## Proposal for Supplement 03 of the 09 series of amendments to UN Regulation No. 14 (Safety-belts anchorages)

Submitted by the expert from Spain

#### "Annex 6

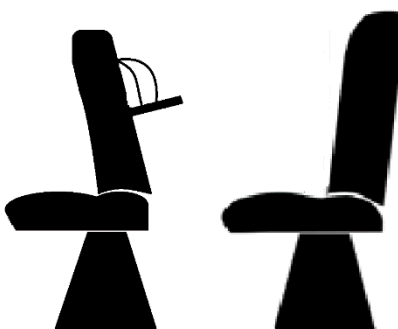
*Annex 6, note a:* amend to read:

1. For M2 and M3 vehicle of all classes, when an adult seating in a forward-facing seat which face a built in Child Restraint system, an impact between the adult and the child shall be prevented.

2. In order to prevent the impact between the occupants a 3-point belt is requested on the adult seating position.
  3. The text has been proposed to be updated in the UN Regulation 16 Supplement 05 to 08 series of amendments, it seeks to harmonize requirements in both UN Regulation 14 and UN Regulation 16.
-

**Note a: For M2 and M3 vehicles of all classes, forward facing Seats facing Built in Child Restraint Systems shall be equipped with at least two lower anchorages and one upper anchorage which allow the installation of three point safety-belts type Ar.**
